ENGINE - FUEL AND CONTROL - CDX MODIFIER ADJUSTMENT FOR DELIVERED ENGINES - CATEGORY
CODE 8 - MOD.ENG-72-0139

V2500-ENG-72-0139

Location of the Data Entry Plug Assembly
Fig.1

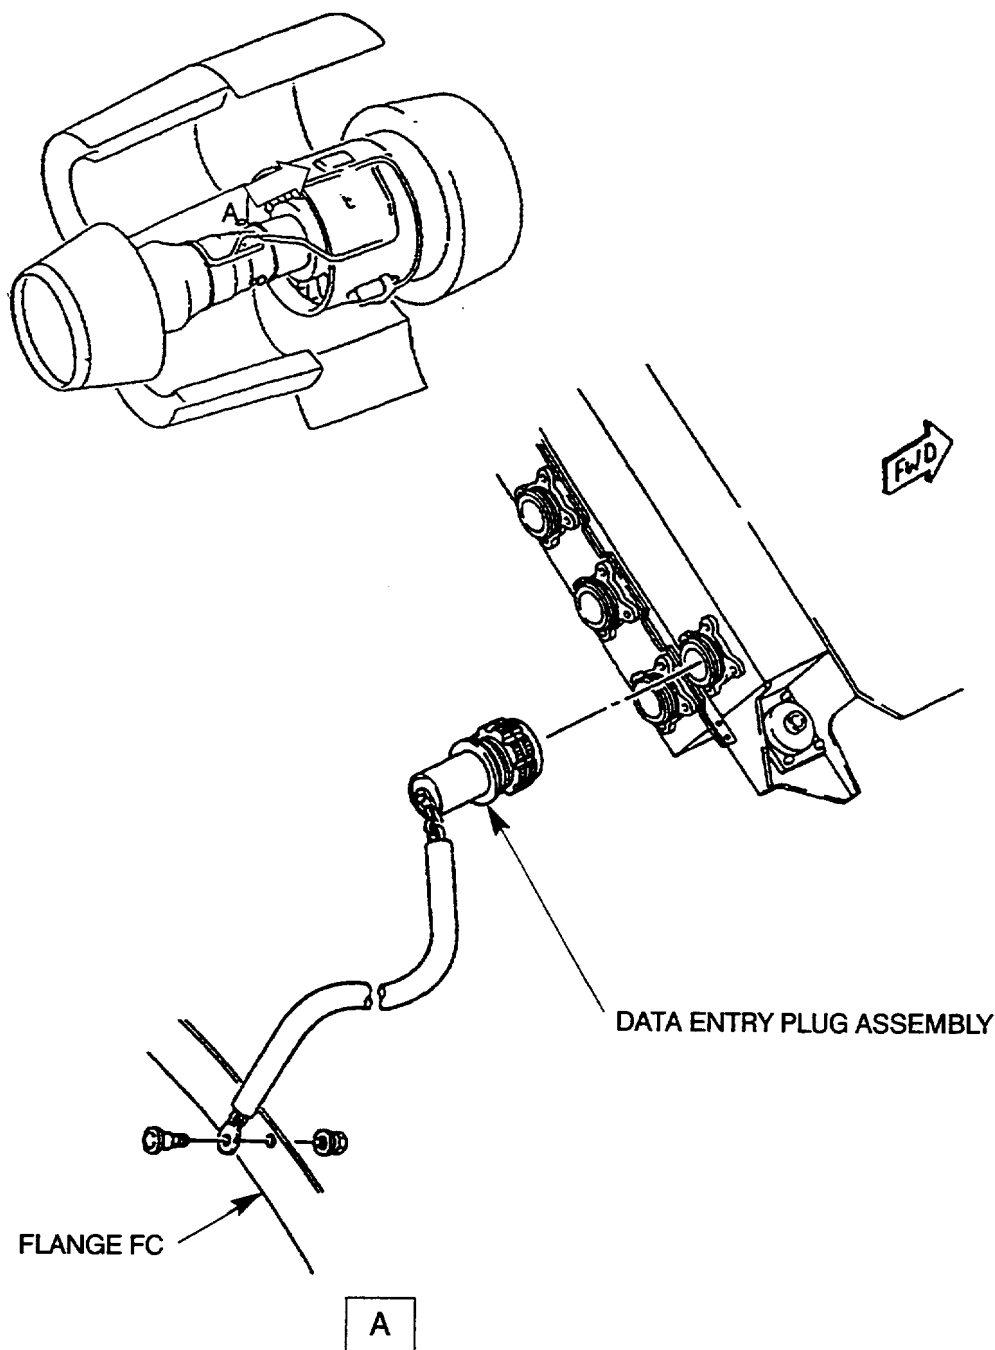
- (1) Remove the Data Entry Plug Assembly by the procedure given in Reference (2), Chapter/Section 73-21-35 Removal/Installation. See Figure 1.

- (1) Disassemble the Data Entry Plug Assembly as necessary to do the specified change to the EPR modifier.
 - (a) Use the procedure given in Reference (3), Chapter/Section 71-00-00, Testing-11.
- (2) Install the applicable jumper wires to do the change to EPR Modifier as specified in Table 1.
 - (a) Use the procedure given in Reference (3), Chapter/Section 71-00-00, Testing-11.

- (3) Make a mark on the backshell of the Data Entry Plug Assembly to show the new EPR Modifier by the procedure given in Reference (3), Chapter/Section 71-00-00, Testing-11.

Table 1 EPR Modifier Changes		
Engine Serial Number	EPR Modifier Before Incorporation of This Service Bulletin	EPR Modifier After Incorporation of This Service Bulletin
V20007	09	10
V20009	09	10
V20010	08	09
V20011	10	11
V20012	09	10
V20013	09	10

Location of the Engine Identification Plate
Fig.2

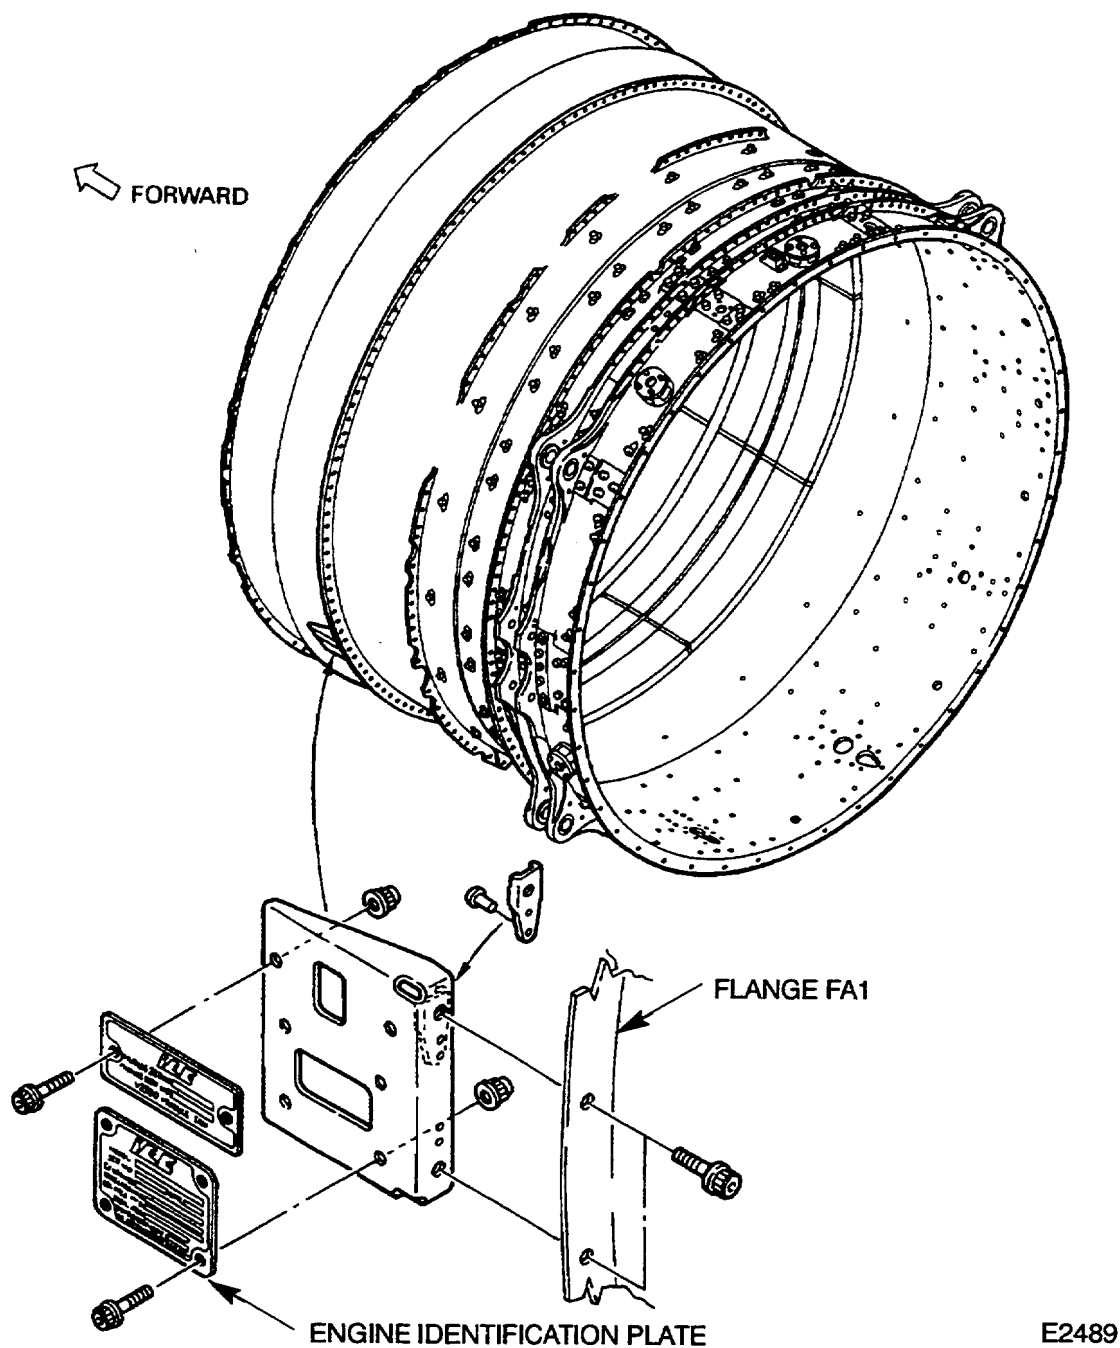
- (1) Install the Data Entry Plug Assembly by the procedure given in Reference (2), Chapter/Section 73-21-35 Removal/Installation.
- (2) Make a mark on the Engine Identification Plate to show the new EPR Modifier by the procedure given in Reference (2), Chapter/Section 73-21-35 Removal/Installation. See Figure 2.
